Bulletin No.: P15-2020  
Date: November 20, 2020

## PRODUCT BULLETIN

**SUBJECT:** Change to Rain Sensor for the Solatube® Operable HSE Skylights

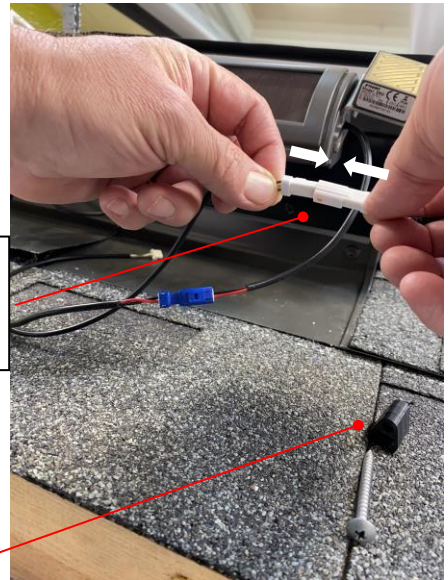
The cable on the rain sensor for the Solatube HSE Operable Skylight has been improved to include a midline connector to ease the installation process.

Rain Sensor

New Inline Cable Connector

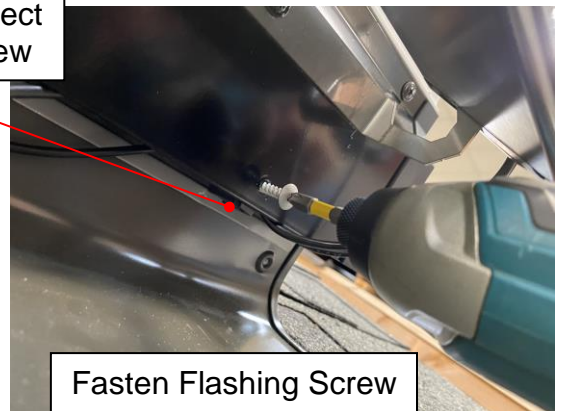
Snap  
Cables  
Together

Use Snap  
Spacers to Protect  
Wires from Screw

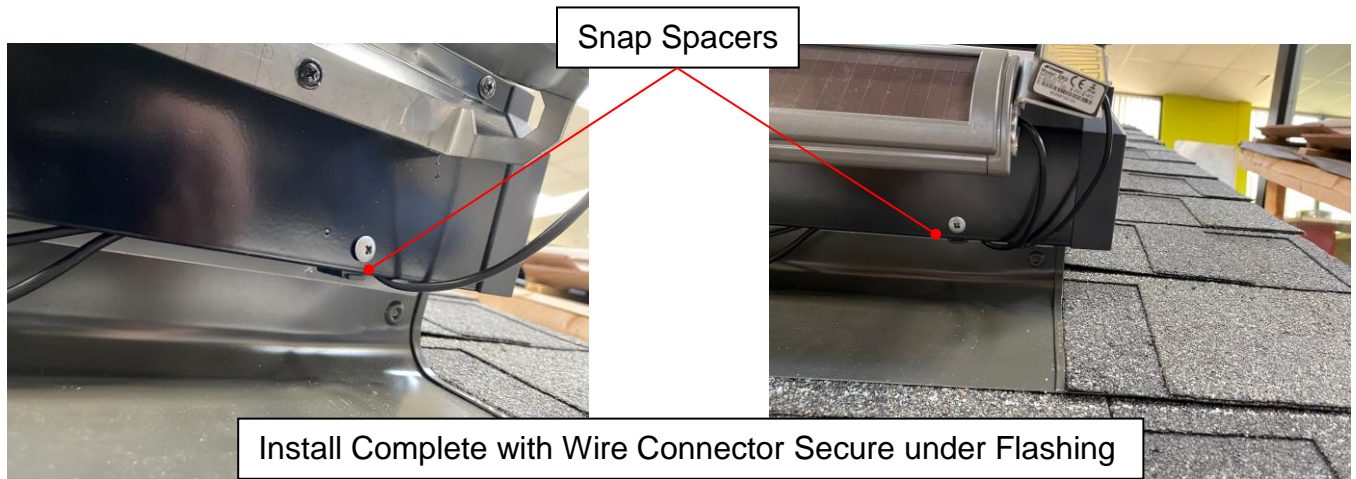
Tuck Wire Connector Under Sash and Install Screw. Ensure Wires are above Screw.

Fasten Flashing Screw
